ADDENDUM NO. 0

Date: May 11, 2022

Issued by: Sacramento City Unified School District

Project: **SCUSD Project No. 454-2
Shade Structures Group 1B**

2 TYPICAL H/20 TRAFFIC RATED PULL BOX

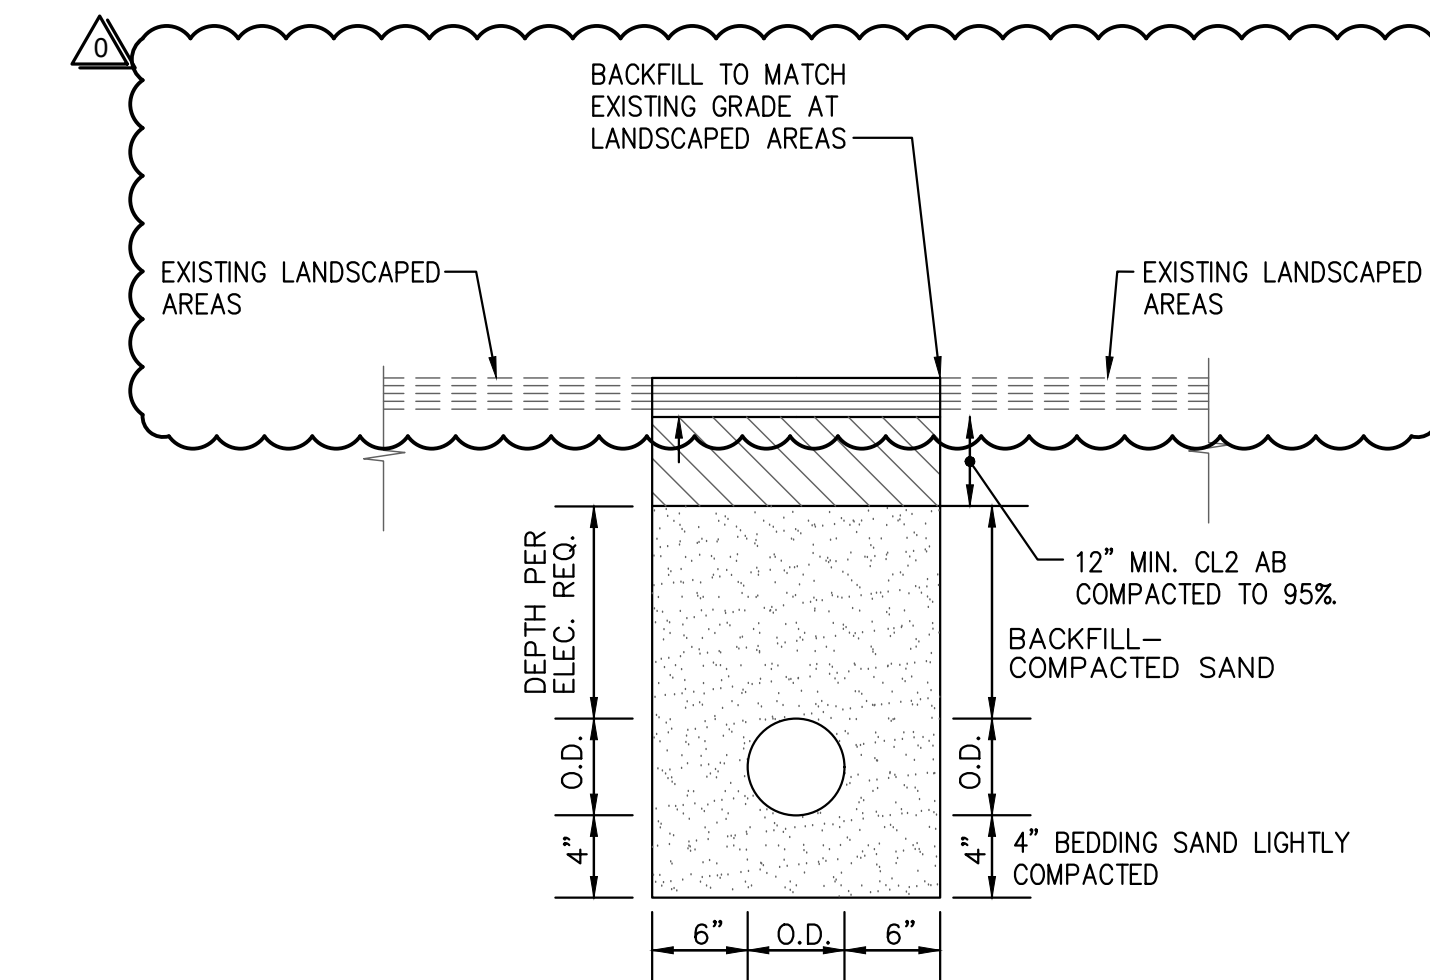
3. ADD Keyed Note 7 per sheet AD0.03 included with this addendum.
- D. Sheet E3.1, Details
1. Detail 2, Typical H/20 Traffic Rated Pull Box: REVISE per sheet AD0.04 included with this addendum.
